Re: Marysville Corporate Center – *Technical Review 3*
PA 22004

PRELIMINARY MARYSVILLE CORPORATE CENTER BINDING SITE PLAN FILE NO. PA22004

RE: Marysville Corporate Center, File# PA22-004
Binding Site Plan
15908 47th Ave., Multiple Parcels

SHEET 1 OF 13

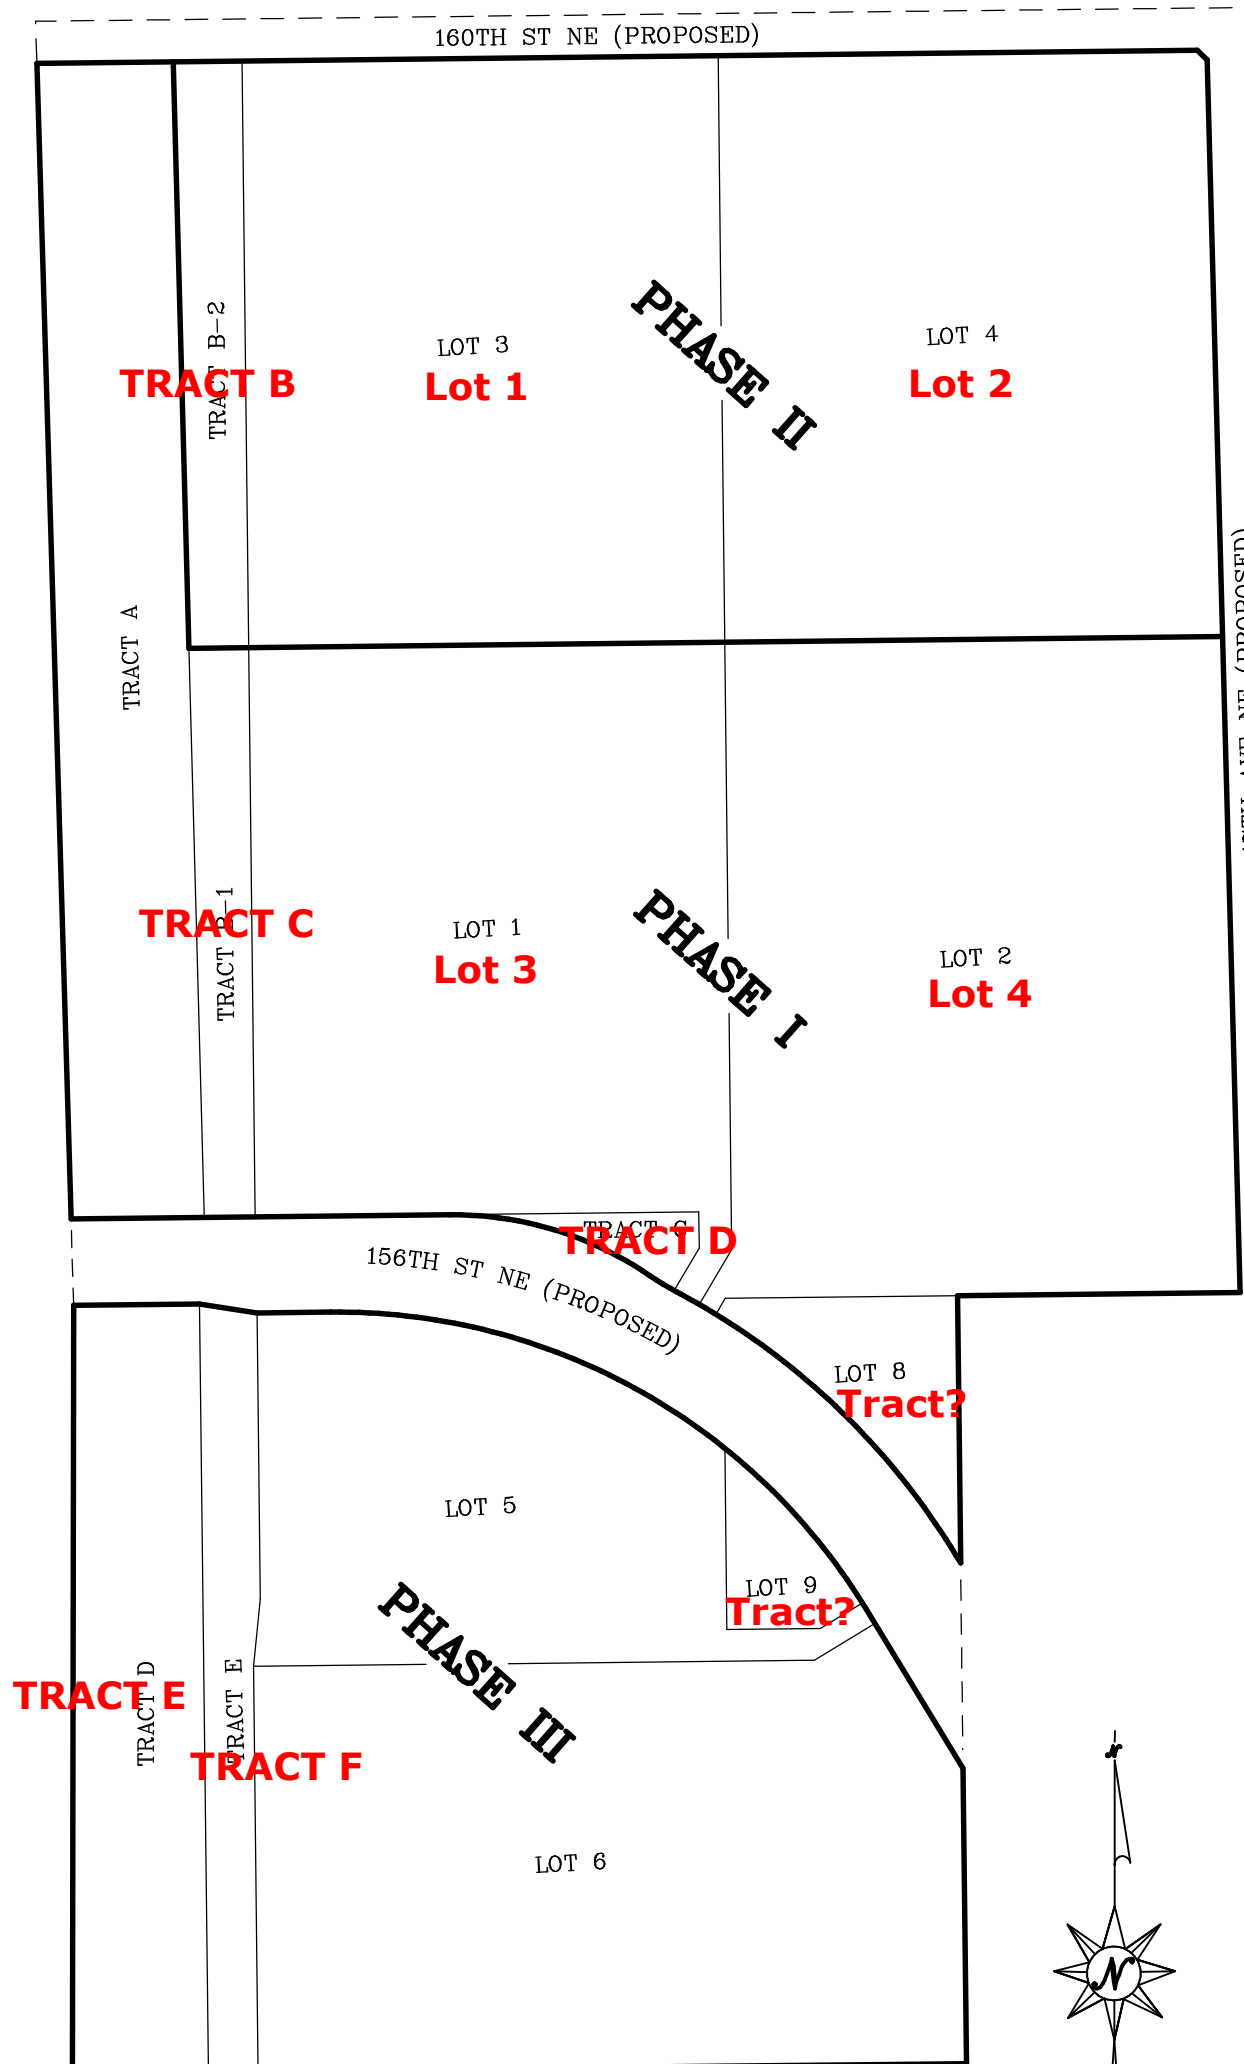
Amend all applicable sheets per the redlines included on this sheet

Provide ADA parking calculations and location of stalls on all applicable sheets.

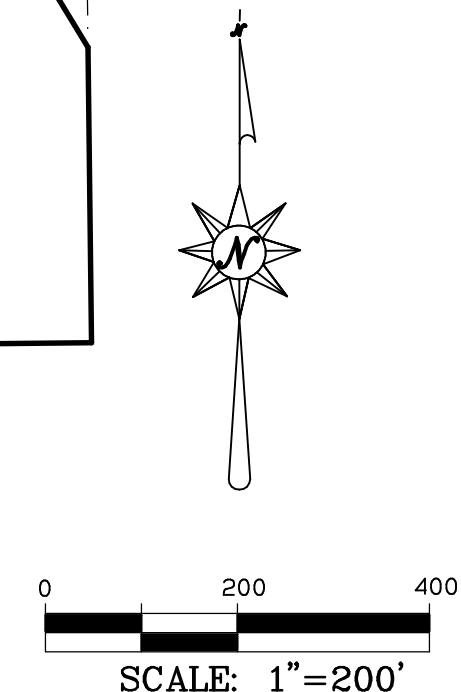
Lots 8 & 9 should be Tracts and added to table
